Addison Airport
Bulk Fuel Storage and Dispensing Facility
Change Order Status
1-12-06

Subject: Addison Texas Airport Fuel Farm
Change Orders 019, 020, 021, 022, 023, 024, 025, and 026

Project No.: WGI-ADS 27514
Addison A/P Fuel Farm
Contract Change Requests

764V FLOATING SUCTION ASSEMBLY

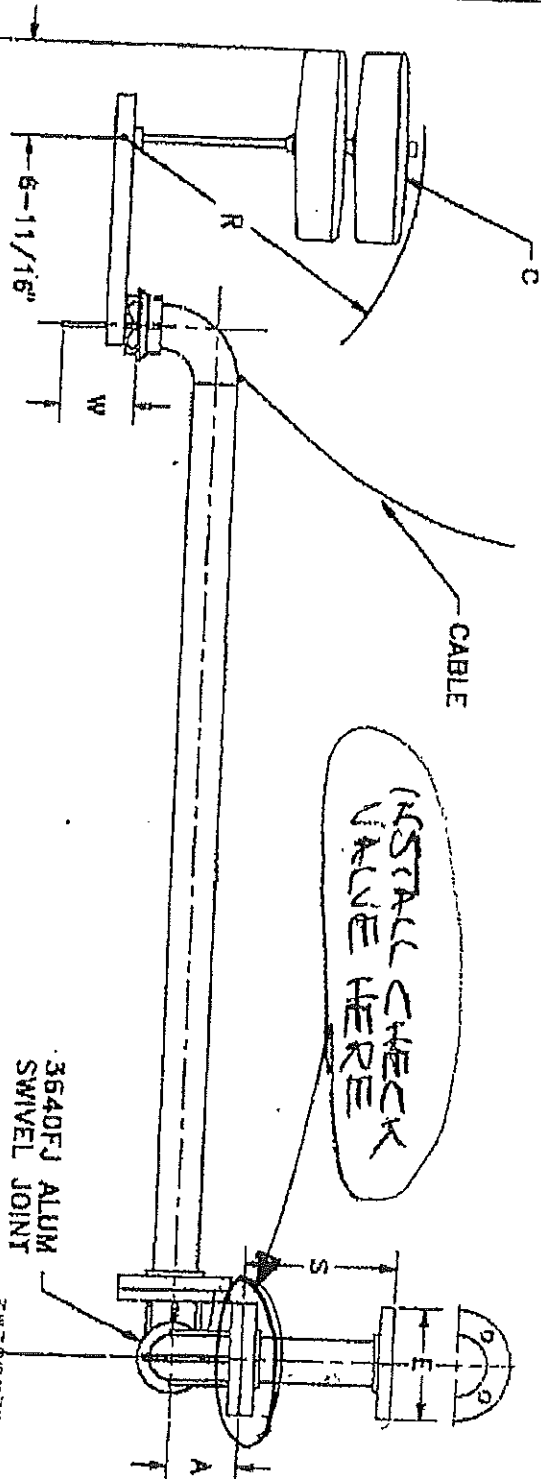
CR 021, Floating Pump Suction: The arm on the floating pump suction was too long to fit into the tanks. The Contractor had to cut a section out of the arm and re-weld the flange. There should be no cost for this item because the Contractor is to provide a complete, functional fuel farm.

DETAILS

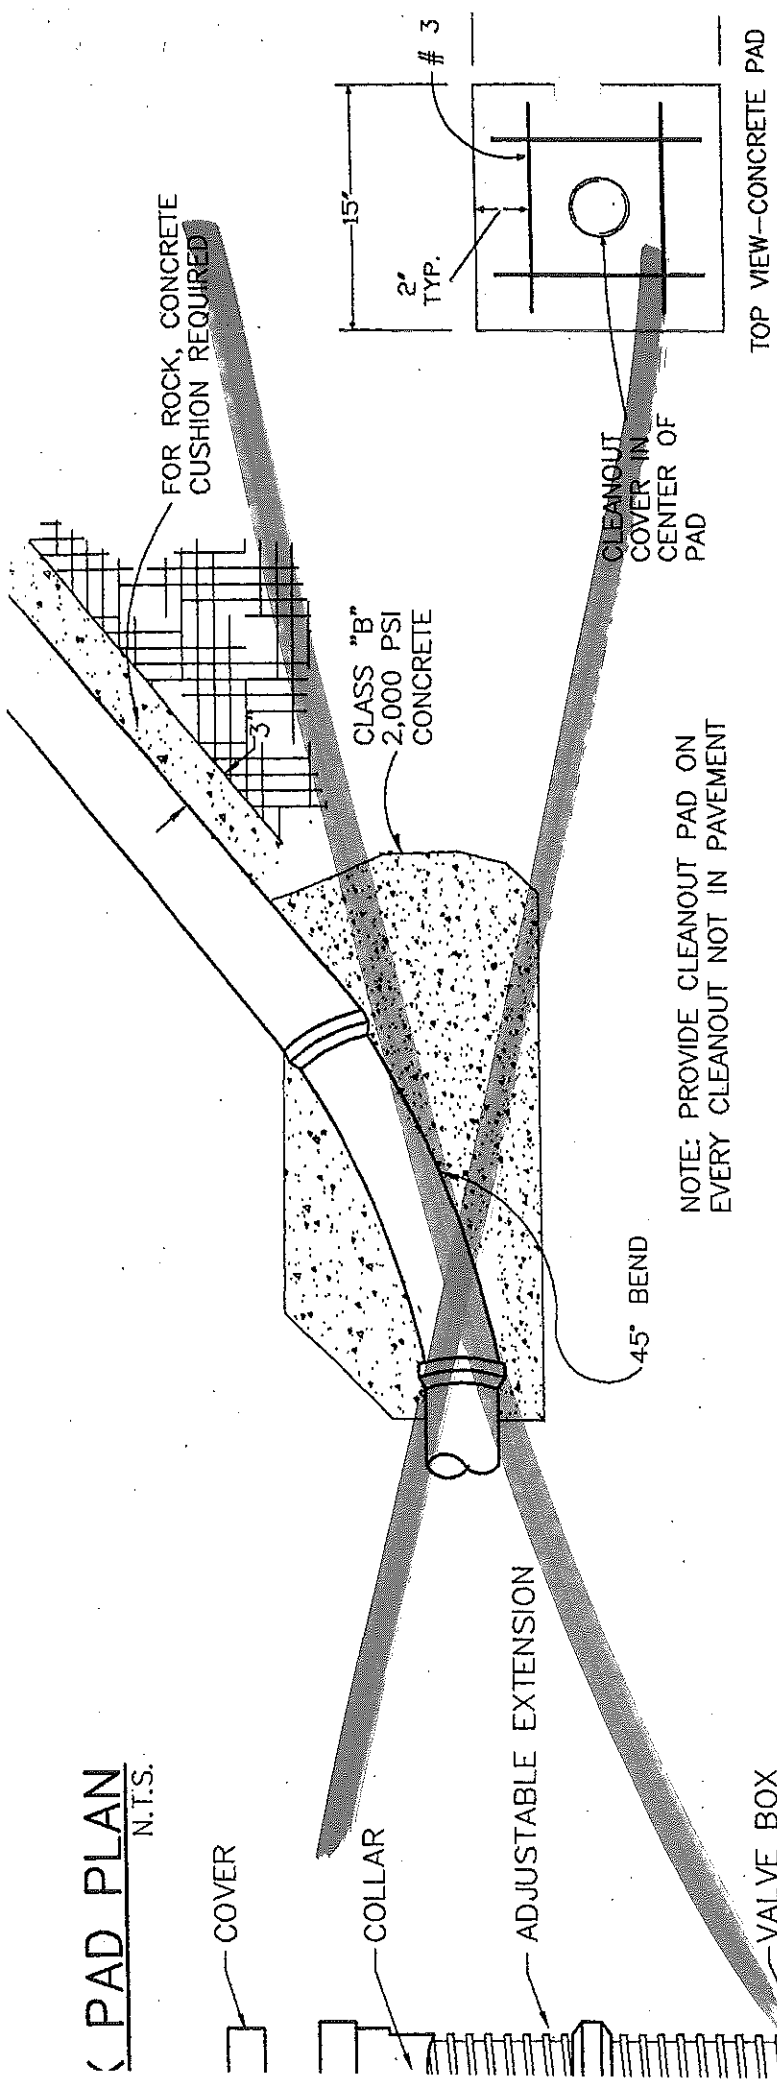
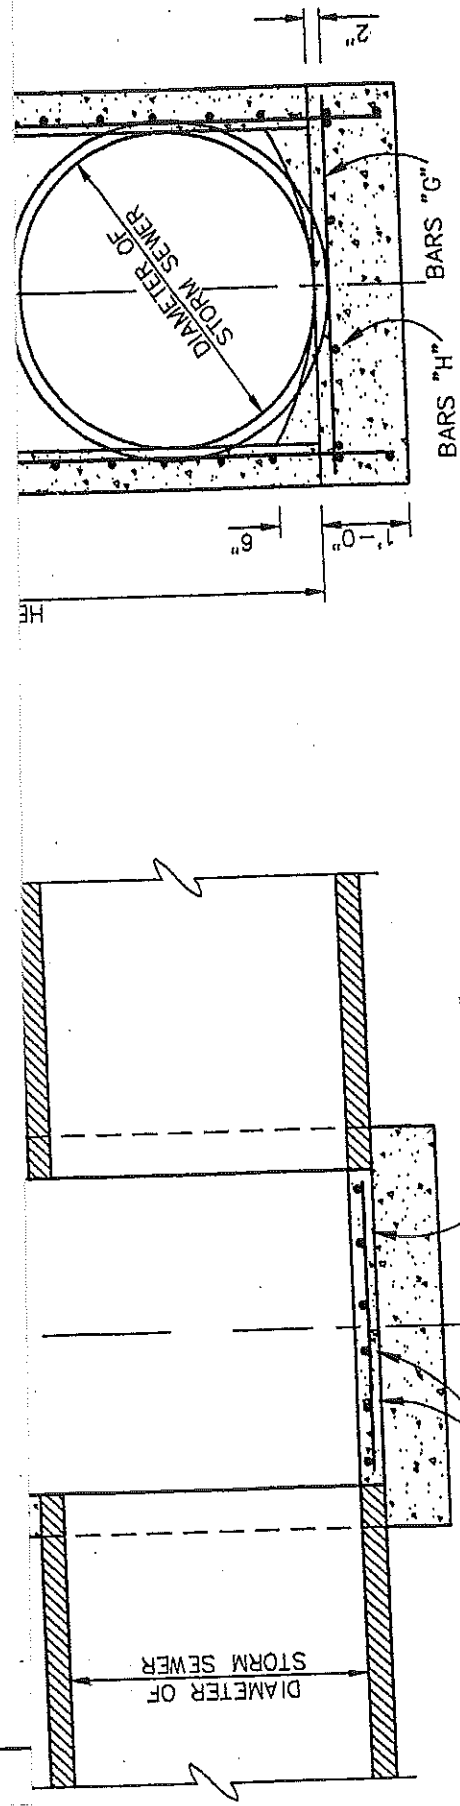
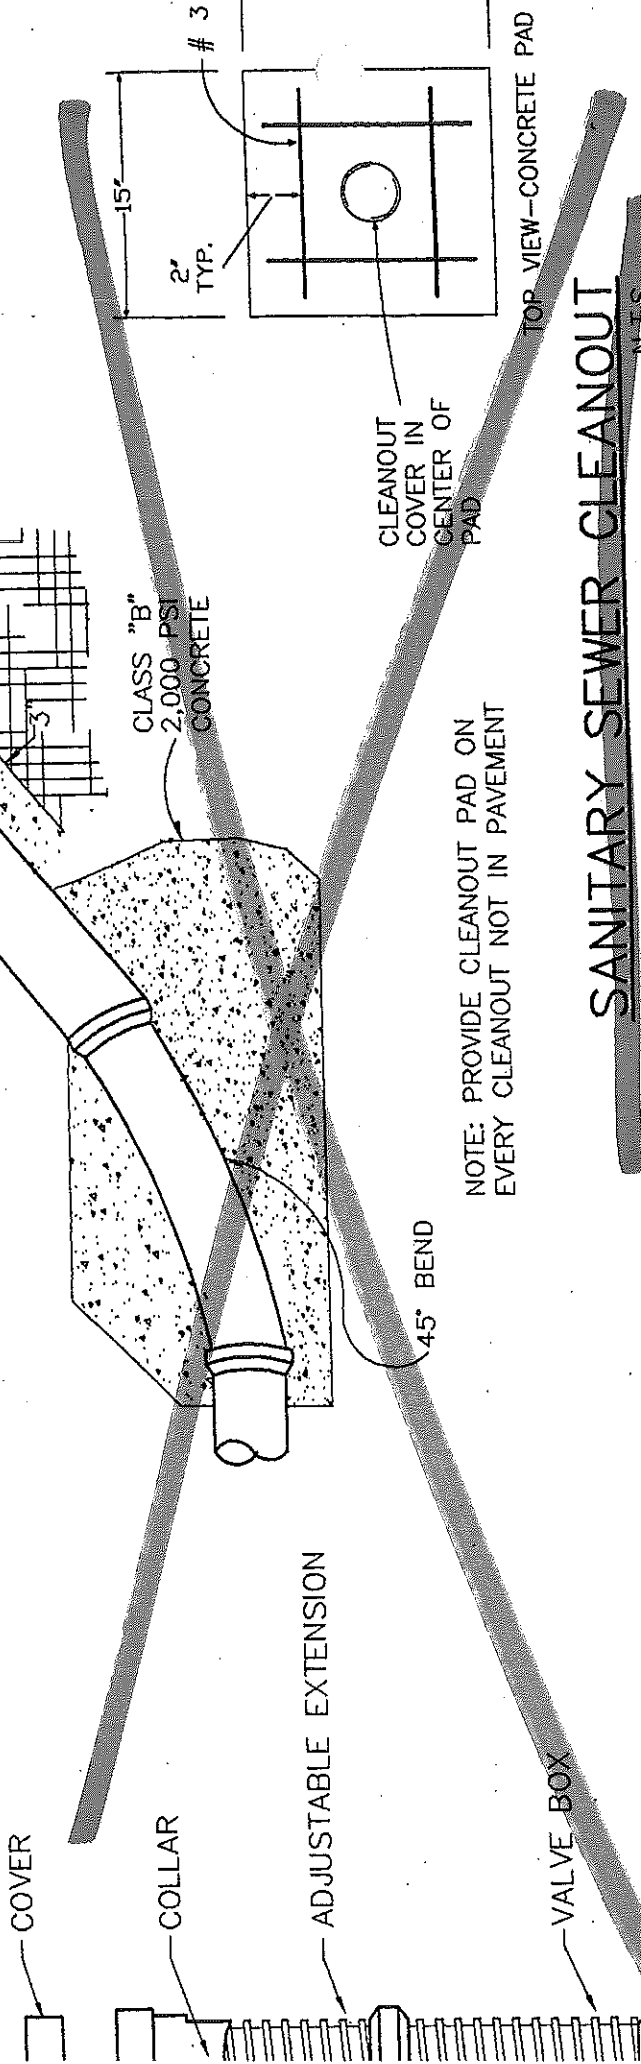
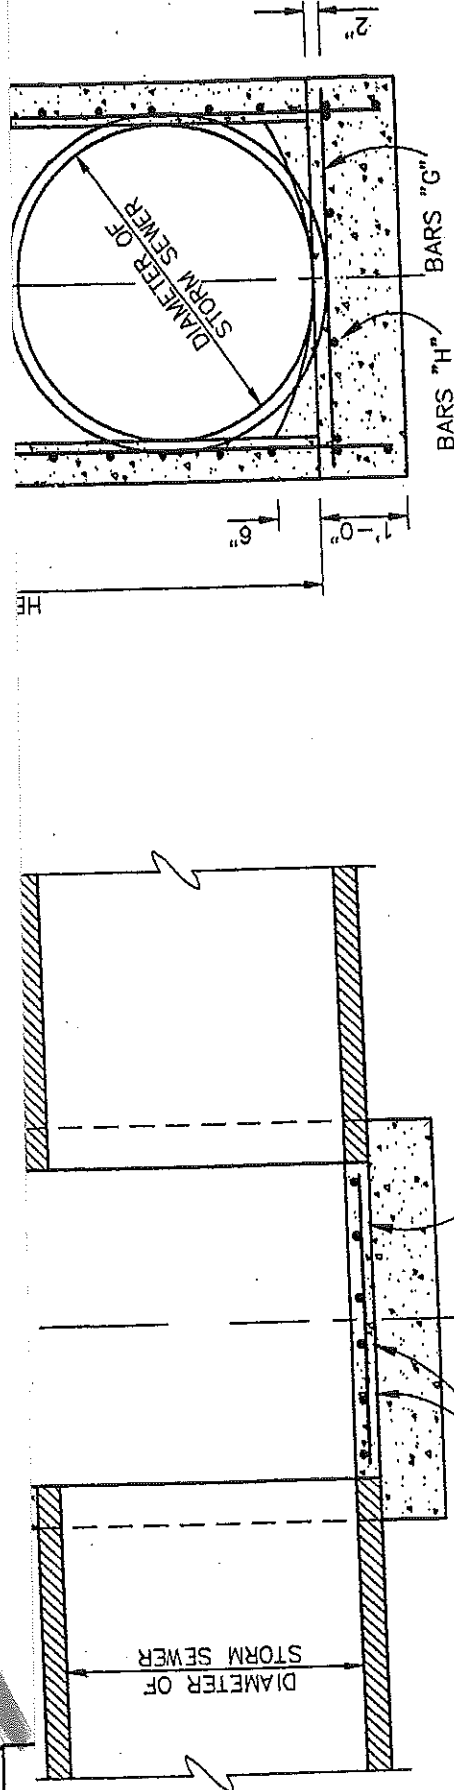
- The contractor submitted a shop drawing to use an alternative OWS than what was shown in the plans. It became incumbent on the contractor at that time to verify that the new OWS would work at this site. It is not the responsibility of the engineer to re-engineer and re-evaluate his/her design with each shop drawing submission.
- Sheet 4 of the project plans lists the "Sequence of Work." This sequence was not followed nor was there a revised sequence of work plan submitted.
 - Note 4 under the "Sequence of Work" states "Construct the underground connection for utilities, conduit and storm system, place pads, cabinets and other supporting structures."
 - Note 5 then states " Construct secondary containment structure and concrete pavement and install the oil water separator"

- Sheet 2, under the "General Notes", note 3 instructs the contractor to verify the location and depth of all underground utilities prior to start of construction.
- It is standard construction practice to build gravity flow systems from the down stream end to the upstream end. That was not the case in this situation. The oil water separator and the secondary containment system were in place before any storm line location was performed.
